ZBA 23-04

302 W. St. Charles Road

A variation from Section 155.409(F)(1)(b) of the Lombard Zoning Ordinance to reduce the required corner side yard setback from twenty feet (20') to eight and four tenths feet (8.4').

Tami Urish  
Planner I

*Subject property viewed from front yard (St. Charles Rd)*

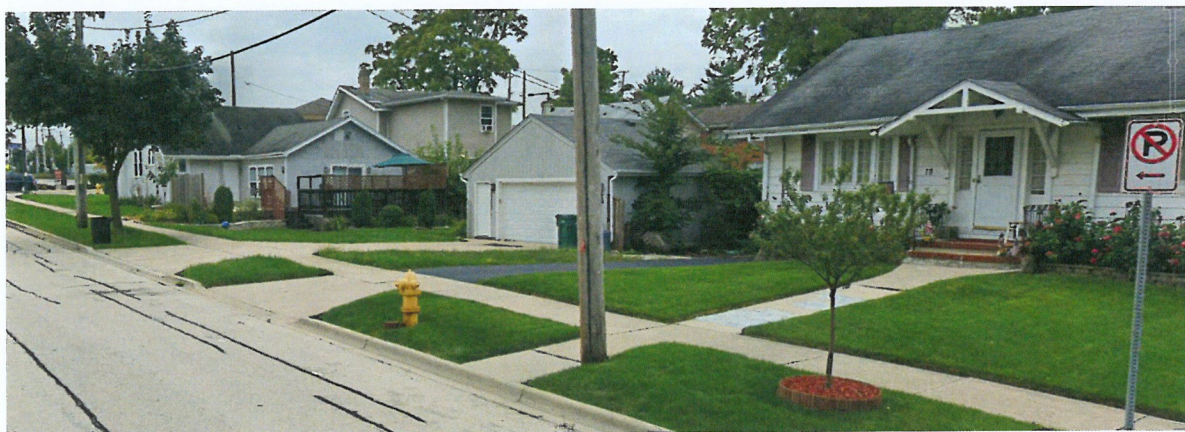
The Zoning Ordinance requires single-family residences in the R4 District to maintain a minimum corner side yard setback of 20 feet and a minimum interior side yard setback of six feet from property line. The residence is not meeting the required 20-foot corner side yard setback relative to the east property line. The petitioner proposes to build a seventy (70) square foot one-story addition onto the house. The proposed addition will hold the existing corner side setback toward the rear of the house along Elizabeth Street.

The one-story addition will hold the corner side yard setback line of the existing house. The corner side setback ranges from 7.36 to 8.4 feet. The proposed addition will maintain the existing eight and four tenths (8.4') corner side yard setback, as the proposed addition is at that location of the house. The addition is not expected to impact light or air supply to the adjacent property.

*Subject property viewed from 18 N. Elizabeth Street (viewshed in line with the subject property's detached garage).*

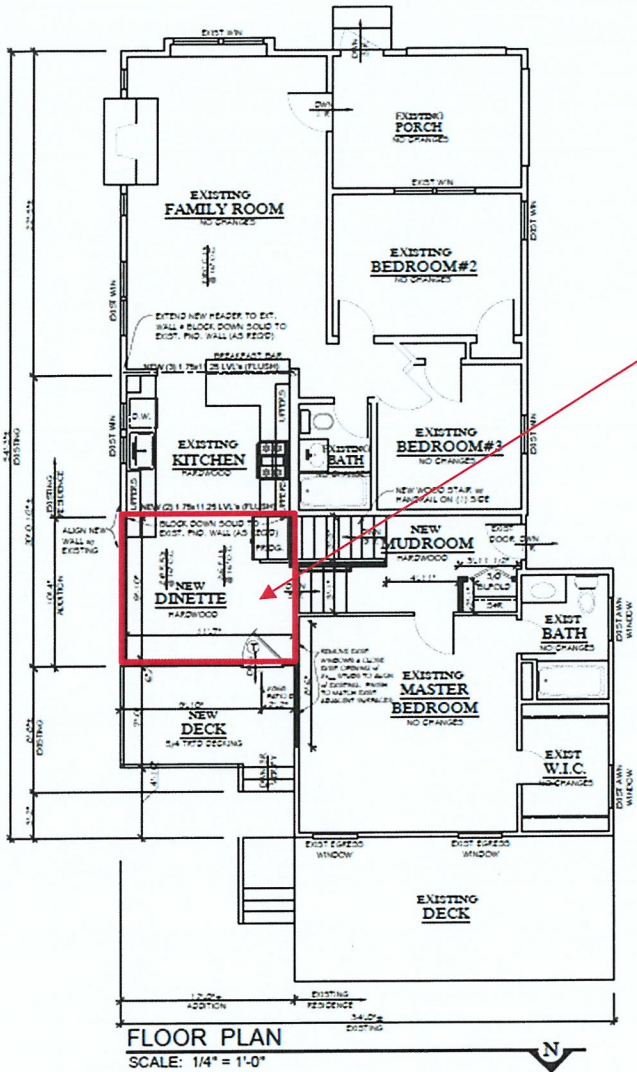
Additionally, there are no residences immediately to the east of the subject property that would be directly impacted by the additional encroachment. The residence to the north is not directly impacted as the subject property's existing detached garage obstructs the view of the small addition.

ST. CHARLES ROAD  
 SITE PLAN  
 SCALE: 3/32" = 1'-0"

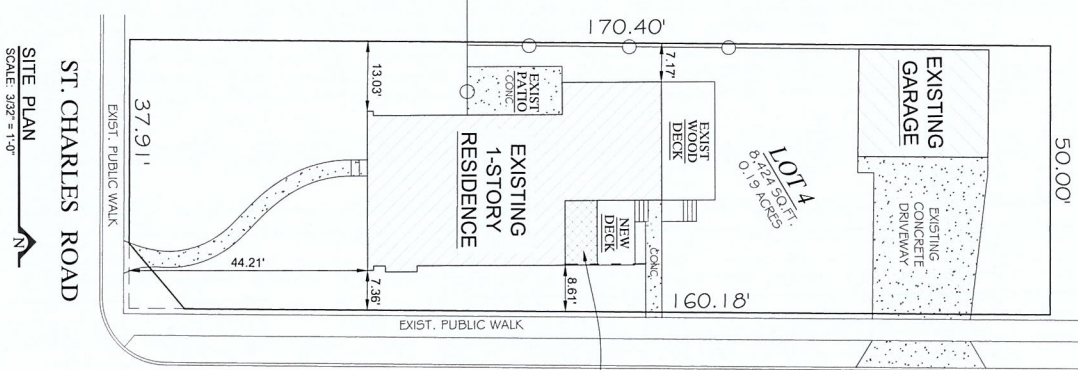
The current Village Code went into effect after the subject property was developed, and contains lot width and setback requirements that the subject property does not meet. Staff recognizes that this development sequence creates a hardship for the property owner attempting to modify a home that was constructed prior to current zoning requirements. The floor plan of the house restricts the options for expanding the kitchen (shown in the red box) and therefore the placement of the addition.

Staff finds that this standard is affirmed. The one-story addition will maintain the existing corner side building line.
